DART SERVICE INSTRUCTION

TO AMEND INSTALLATION INSTRUCTIONS D350-591 REV. G
AND INSTRUCTIONS FOR CONTINUED AIRWORTHINESS ICA-D350-591 REV. 3

TO PROVIDE AN OPTIONAL CUSHION KIT TO BE INSTALLED ON THE D350-591-111A/-113/-115/-117A/-119 *Heli-Access-Step*™ (THE D2856-400-720 ABRASION STRIP IS REPLACED WITH THE D3595-200-300 CUSHION).

A	NEW ISSUE.	JPH	10.06.08
REV.	DESCRIPTION	BY	DATE
DESIGN		DART AEROSPACE LTD	
DRAWN		HAWKESBURY, ONTARIO, CANADA	
CHECKED		DRAWING NO.	REV. A
MFG. APPR.	N/A	DSI 9525	SHEET 1 OF 4
APPROVED		TITLE	SCALE
DE APPR.		STEP CUSHION CHANGE	NTS
DATE	10.06.08	COPYRIGHT © 2010 BY DART AEROSPACE LTD THIS DOCUMENT IS PRIVATE AND CONFIDENTIAL AND IS SUPPLIED ON THE EXPRESS CONDITION THAT IT IS NOT TO BE USED FOR ANY PURPOSE OR COPIED OR COMMUNICATED TO ANY OTHER PERSON WITHOUT WRITTEN PERMISSION FROM DART AEROSPACE LTD.

FIGURE 32-9: Crosstube Attachment
REF ICA-D350-591

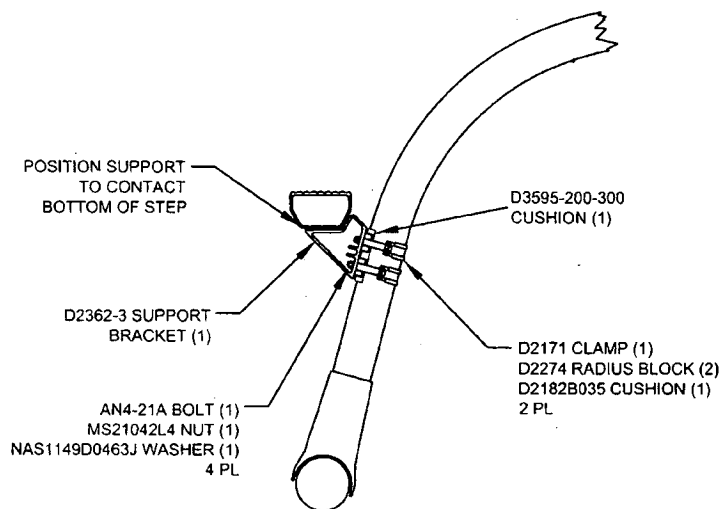
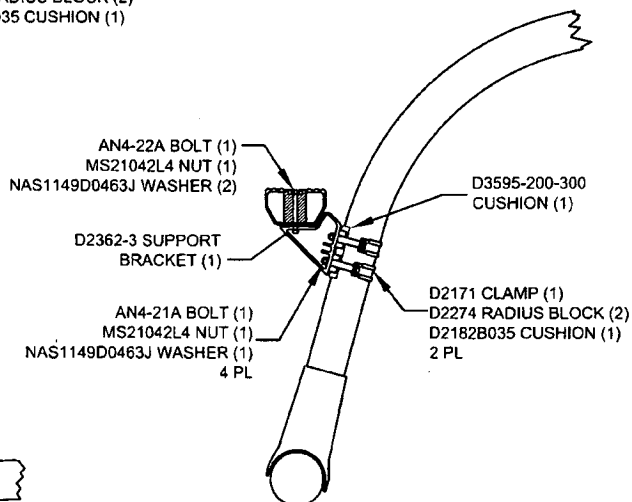
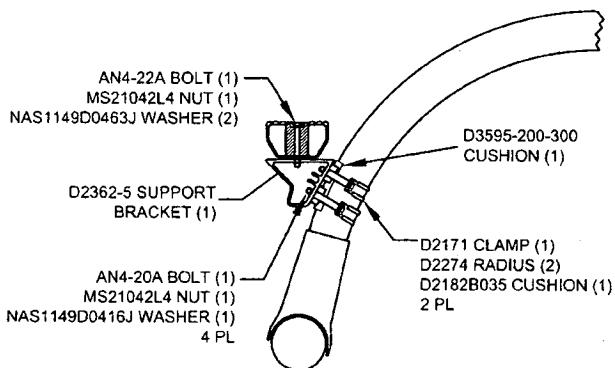
1. REMOVE THE STEP PER ICA-D350-591 SECTION 32.2
2. REMOVE THE D2856-400-720 ABRASION STRIP PER ICA-D350-591 SECTION 32.4
3. POSITION THE D3595-200-300 CUSHION AS INDICATED ON SHEET 3 OR 4 (AS APPLICABLE) OF THIS SERVICE INSTRUCTION.
4. REINSTALL THE STEP PER ICA-D350-591 SECTION 32.1 AS APPLICABLE USING THE NEW HARDWARE PROVIDED AS SHOWN ON SHEET 3 OR 4 (AS APPLICABLE) OF THIS SERVICE INSTRUCTION.
